Village of Bayside
9075 N. Regent Rd.
Architectural Review Committee Meeting
July 15, 2019
Village Board Room, 6:00pm

**ARCHITECTURAL REVIEW COMMITTEE
AGENDA**

<p>PROJECT/SITE OWNER: Charles Hoke</p> <p>PROJECT ADDRESS: 9008 N Bayside Drive</p>	<p>PROJECT SUMMARY: 292 Sq Ft Addition in front of house to match existing siding / materials.</p>
--	--

VILLAGE CODE REVIEW

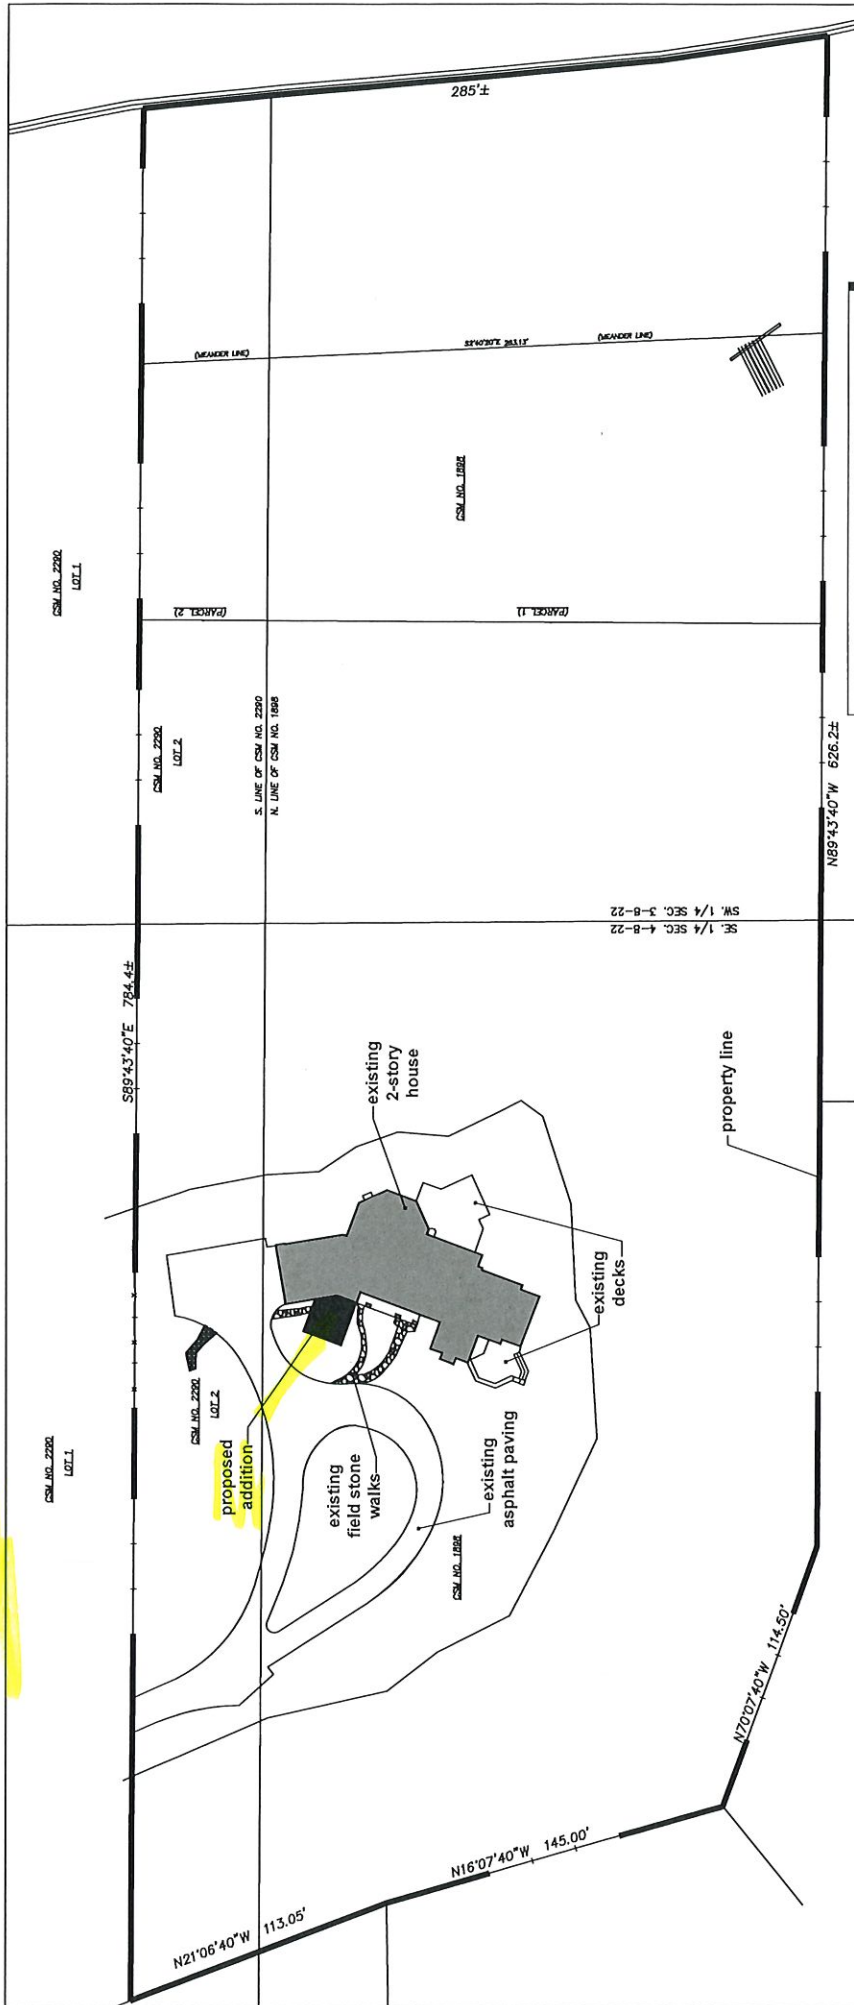
1: New exterior window, adjacent to the new exterior door, shall be safety glazing per SPS 321.05(3)(1):

1. In any sidelight or glazing adjacent to a door, that meets all of the following:

- a. The nearest point of the glazing is within 2 feet of the door when the door is in the closed position.*
- b. The nearest point of the glazing is within 5 feet of the floor.*
- c. The plane of the glazing is within 30 degrees of the plane of the door when the door is in the closed position.*

2: A three-foot landing, measured in the direction of travel, shall be provided at the bottom of the new exterior stair at the new exterior door per SPS 321.04 (4) (b). Distance to existing garage wall is not provided. Three-foot-long landing shall be as wide as the stairs.

HEIGHT:

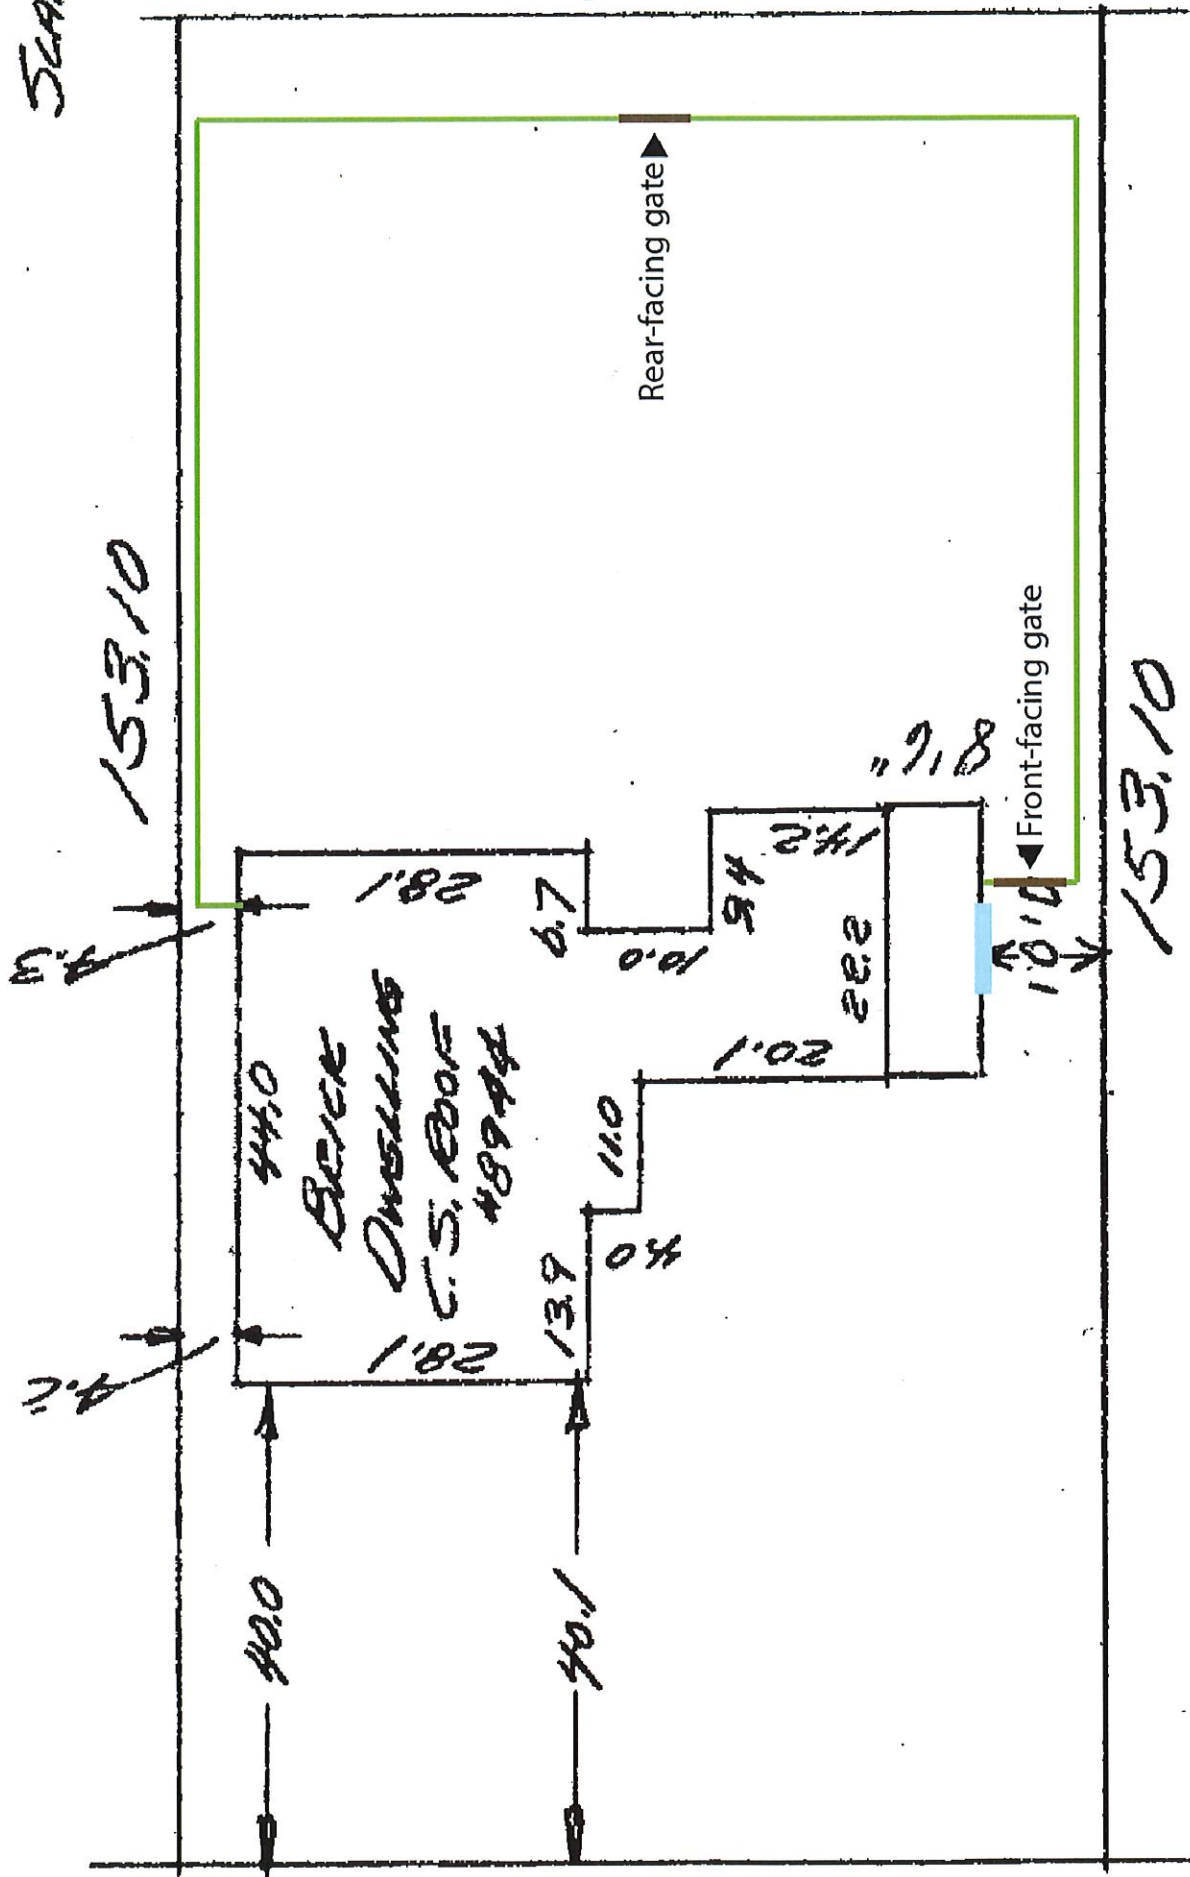
PROPOSED HEIGHT COMPLIES
